GE Hitachi Nuclear Energy

MFN 08-154

**Subject: Response to Portion of NRC Request for Additional Information
Letter Nos. 125 and 135, Related to ESBWR Design Certification
Application – Human Factors Engineering - RAI Numbers 18.2-19,
18.2-20, 18.4-16 S02, 18.4-21 S01, 18.4-25 S01, 18.7-7 S02, 18.11-32
S01, 18.12-2 S01, 18.12-3 S01**

Figure 4 HFE Issue Safety/Risk Significance Methodology

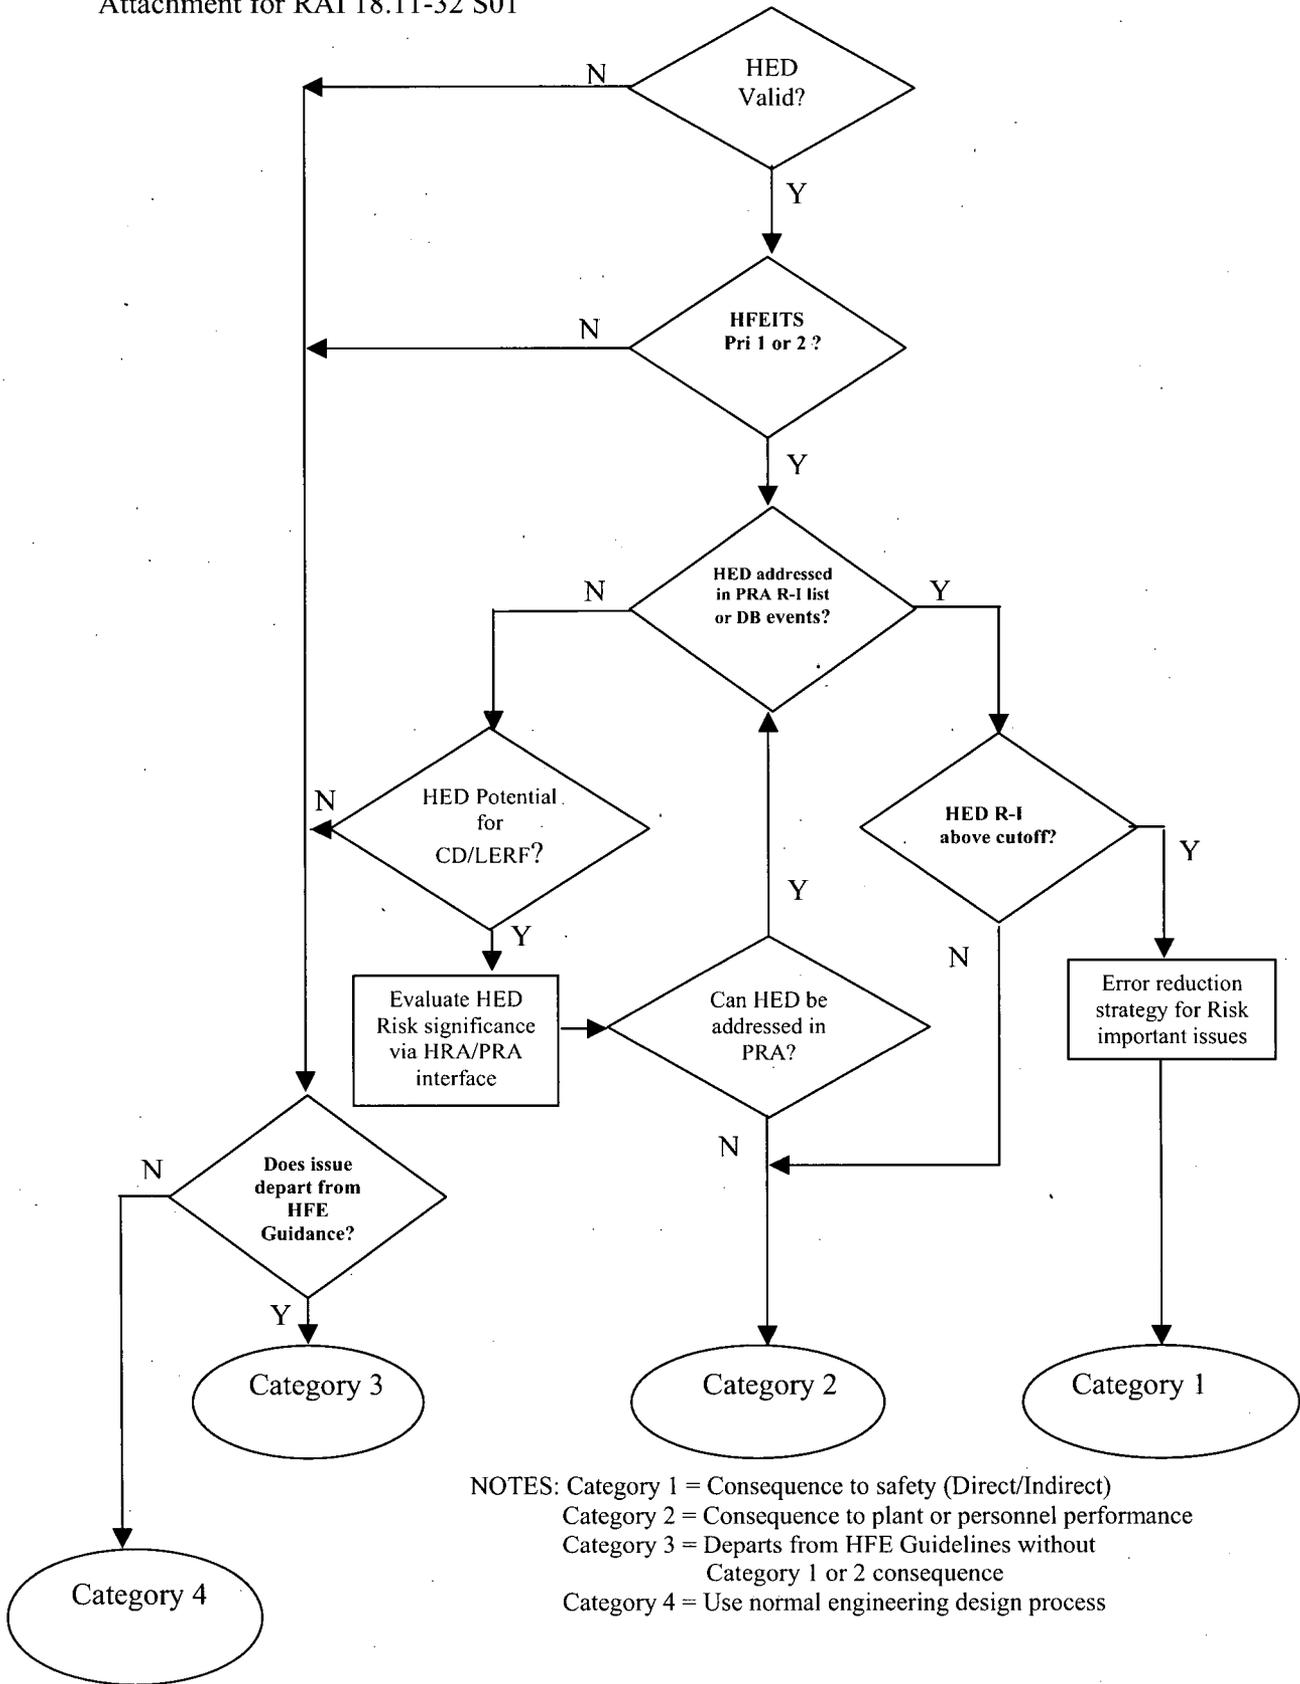
- A. Is there a provision for justifying a discrepancy, e.g., deviation from the style guide with justification?*
- B. In Figure 4, at decision point 4, "Does Issue Meet Style Guide Requirements," actions are described for answering the question as "yes" or "no." However, for some issues meeting the style guide requirements is irrelevant. For example, an issue may be identified in integrated system validation, that a task could not be completed in time due to operator workload. In this case, the style guide requirements are not likely to be related to the issue. Instead, task reallocation to other personnel or automation may be the solution. Why is there no path to follow when the analyst concludes the issue is not related to style guide compliance?*

- C. Another point of clarification relates to the final solutions identified. They appear to be overly restrictive. For example, if an issue cannot be addressed in PRA, the analyst is guided to consider changing training, procedures, or staffing/qualifications. However, as in the example above, task redesign or increased automation may be warranted. Are the proposed solutions limited to those shown in the figure?*

Deviations from the style guide will be required and need to be justified. The style guide requirements statement will be removed from Figure 4 in order to provide a more inclusive review and follow-up flow path and to more accurately match DCD and NUREG-0711 requirements.

1. Figure 4 will be replaced in its entirety. See new Figure 4 Attachment.
2. Section 4.6 will be revised in its entirety and will include two new subparagraphs: See new Section 4.6 Attachment.
 - 4.6.1 Evaluation of HFE Issue Safety and Risk Importance Category 1 and 2
 - 4.6.2 Normal Engineering Processing Category 3 and 4.

LTR NEDO-33276, Rev 1 will be revised as noted above and shown in the attached markups of new Figure 4 and revised section 4.6 (see Attachment).
